METROPOLITAN GOVERNMENT OF NASHVILLE AND DAVIDSON COUNTY

STAFF RECOMMENDATION
1228 4TH Avenue North
March 18, 2020

Application: Final SP Review—Infill
District: Germantown Historic Preservation Zoning Overlay
Council District: 19
Map and Parcel Number: 08209032200
Zoning: SP
Applicant: Matt McCreary and Brian Haun, Allard Ward Architects
Project Lead: Melissa Baldock, melissa.baldock@nashville.gov

Figure 1. 1228 4th Avenue North

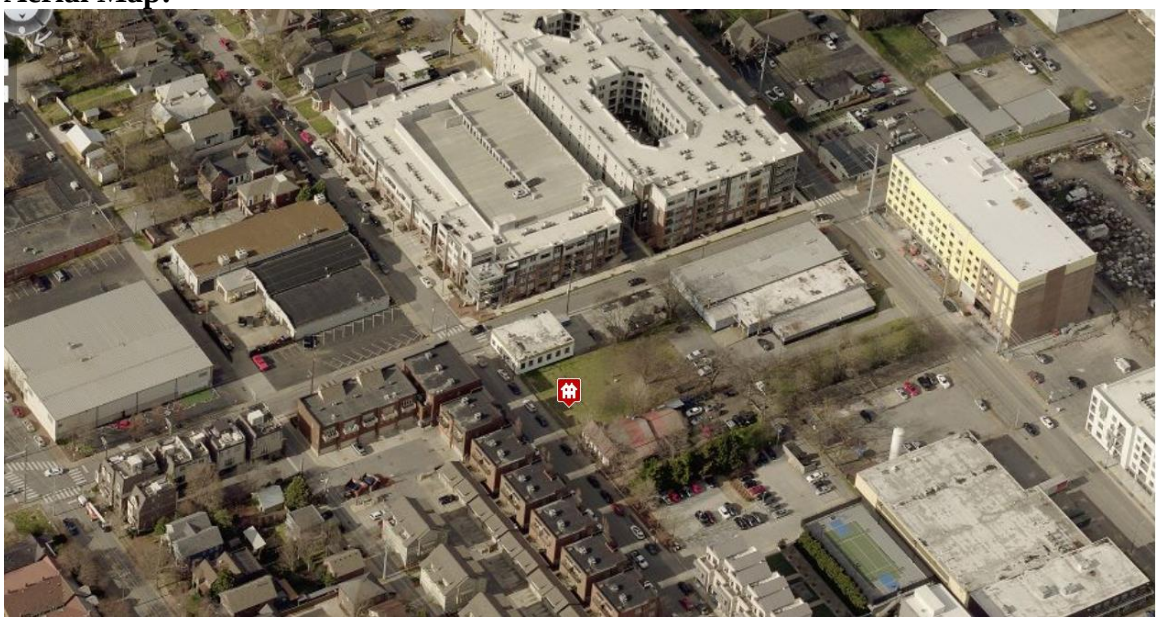
Background: 1228 4th Avenue North is a vacant lot in the East Development Zone of the Germantown Historic Preservation Zoning Overlay (Figure 1). The lot is approximately ninety feet wide and one hundred and eighty feet deep (90' X 180').

2 Front Units: South Elevation

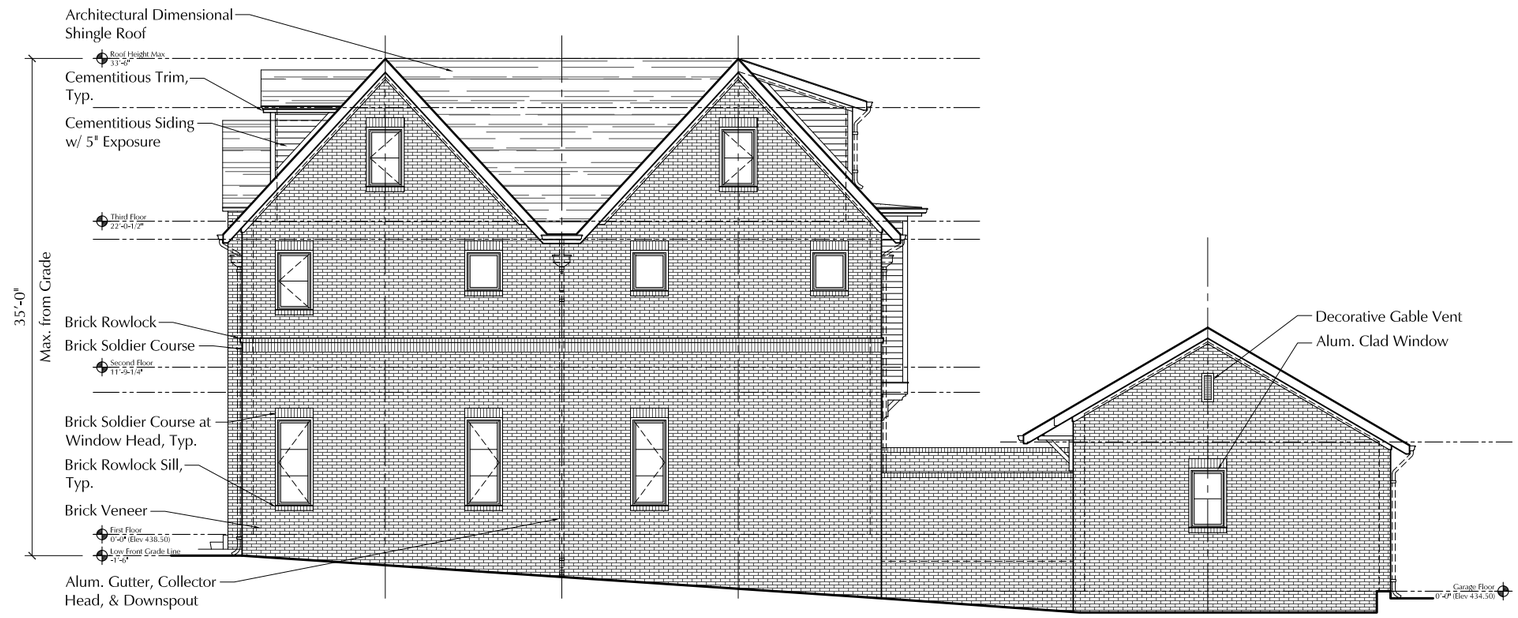
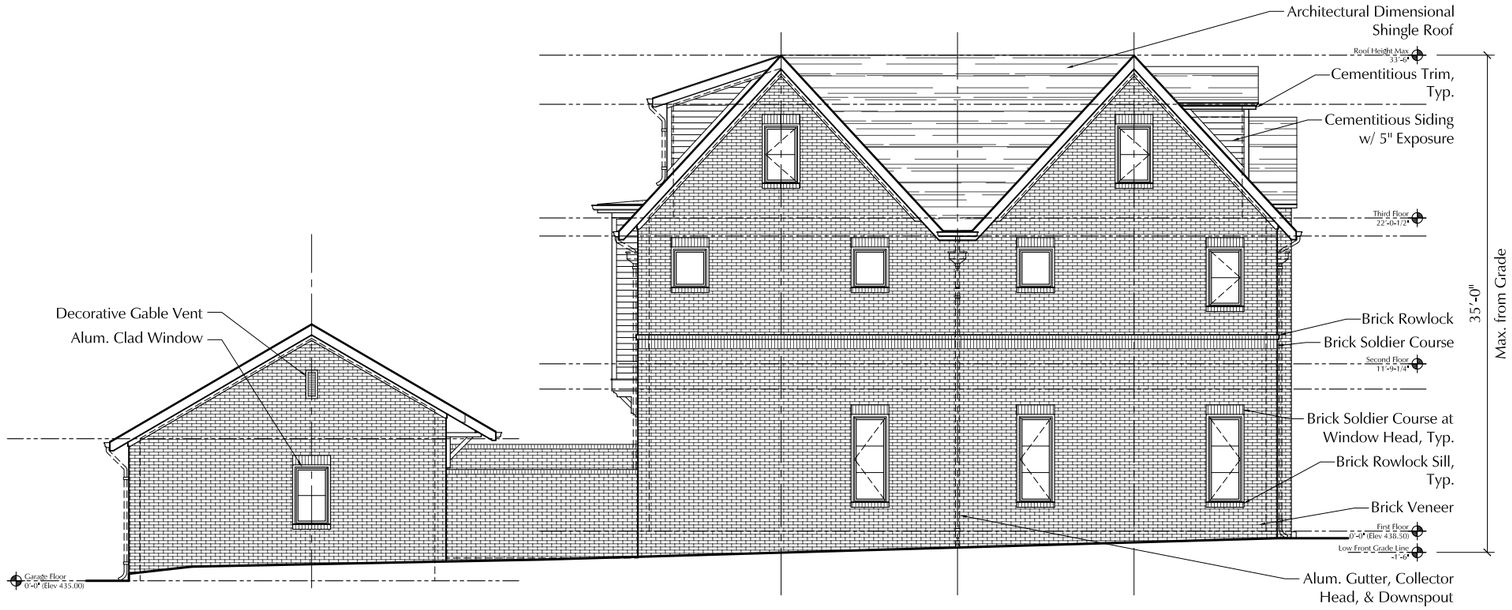
Façade Articulation: The townhouses facing 4th Avenue North are articulated with three bay towers with front-facing gables. This helps to break up the walls of the front façade and to define the three different townhouses. The rear units will not be highly visible from the street. They too will be broken up with oriels to help define the townhouse units.

Roof: The roof forms were approved by MHZC in the preliminary SP review. As mentioned under "Height and Scale," the drawings submitted for the Final SP review differ from the previously approved forms in two ways. One, the detached garages in the middle of the lot now have gabled roofs rather than roofs that are part gable, part flat. Staff finds this to meet the design guidelines. Two, the 4th Avenue North townhouses now have gabled dormers facing 4th Avenue North. Staff recommends that these dormers be eliminated, as they increase the perceived height from two stories to two-and-a-half stories.

With the elimination of the dormers on the 4th Avenue North façade of the front building, staff finds that the development's roof forms to meet Section III.E.8. of the design guidelines.

1. The dormers on the front façade be removed;
2. A brick rowlock, soldier course, or other design detail be included at the foundation line;
3. The brick walls have a maximum height of 6' from grade, as measured from the back of the townhouse;
4. Staff approve a brick sample, stone sample, tile sample, all windows and doors, the roof shingle color, the exterior lighting fixtures, the walkway and driveway materials, and all other materials prior to purchase and installation;
5. Staff approve the location of HVAC; and,
6. A new brick public sidewalk to match the historic brick sidewalks of Germantown be installed in front of the development.
